Subject: Description of Permissive Change

FCC ID: 2AK23MC120
Model Name: MC120LT,MC120BS.
Original Grant Date: 04/20/2018

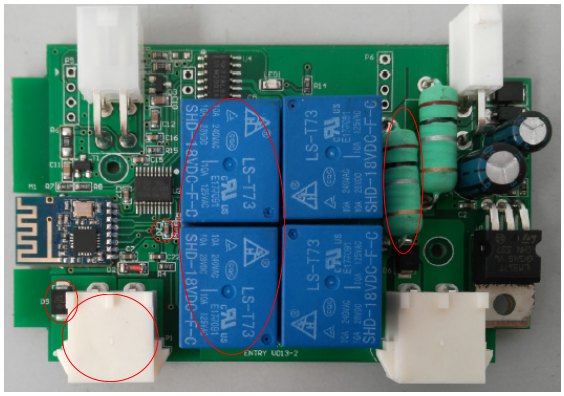
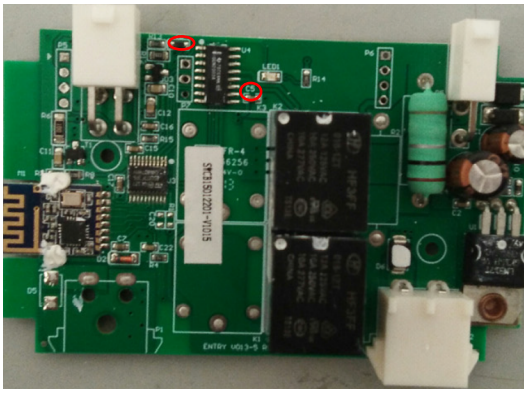
1. Change the model form MC120LT, MC120BS to MC120, MC120BK, MC120BA, MC120SP, MC120LB, MC120LS, MC120TS, MC120SG .
2. The board is different:
   (1)Removed: K1, K3, R2, C20, P1, D5 .
   (2)Added:D7,C5.
